STATE OF MAINE
DEPARTMENT OF TRANSPORTATION
16 STATE HOUSE STATION
AUGUSTA, MAINE
04333-0016

May 17, 2004
Subject: Eddington
Project No. 11988.00
PIN 11988.00
Bid Amendment No. 1

7	SIDE WALLS FOUNDATION DTLS
3	1/2" = 1'0"

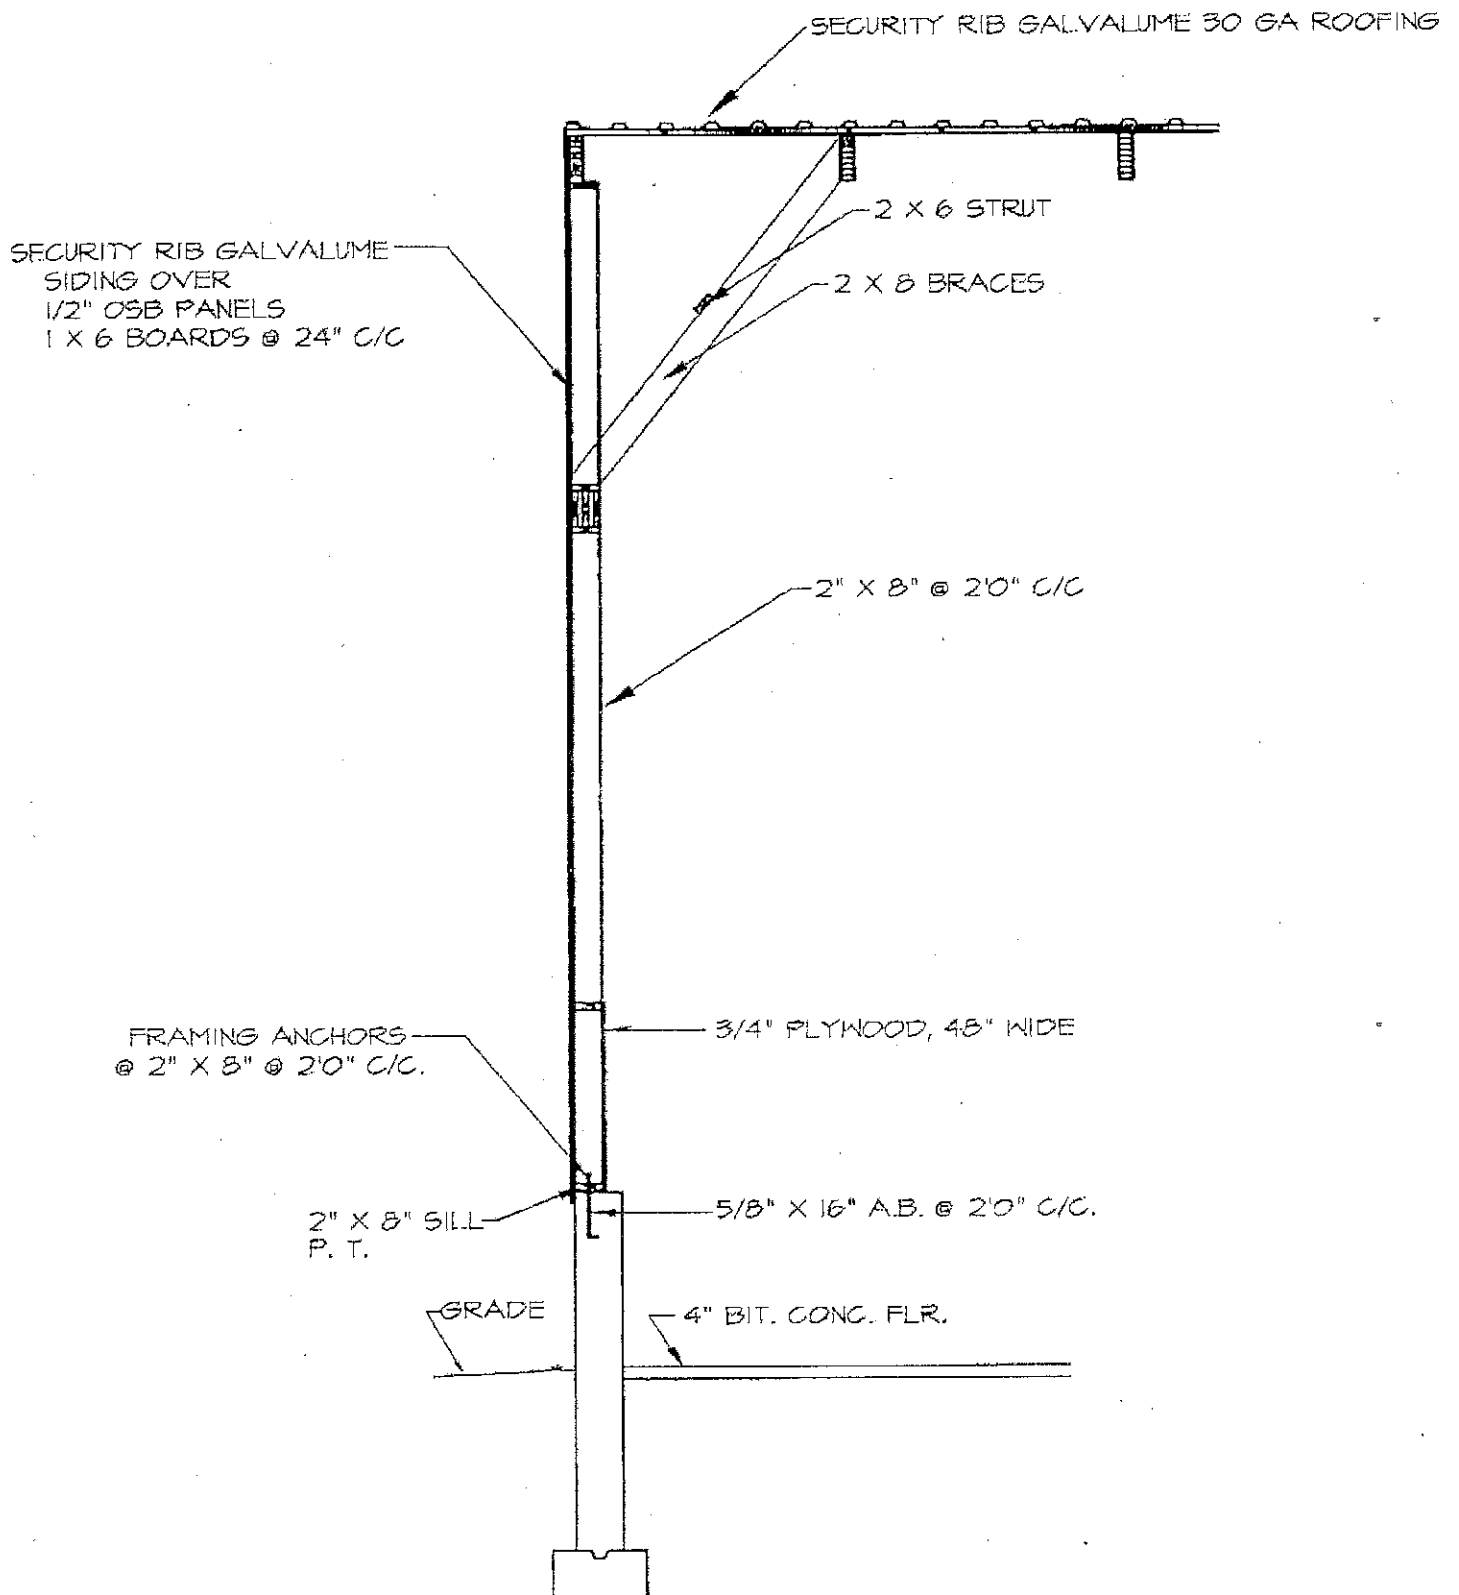
Q: We are to lay a 2"x8" PT sill on top of the concrete walls. The glue lams are 3.125"x12". The detail shows the glue lams attached to sill with a galv. saddle clip & full bearing on the 2"x8". How do we achieve full bearing?

R: *2"x8" P.T. sill is on the end walls only. The glue-lam shoes go directly on the concrete other than any grout that might be needed if the top of the wall is not true to grade. The side wall anchor bolts on drawing 7/3 should be labeled four 5/8" anchor bolts at 6'-0" c/c to match layout of shoes for the glue lams.*
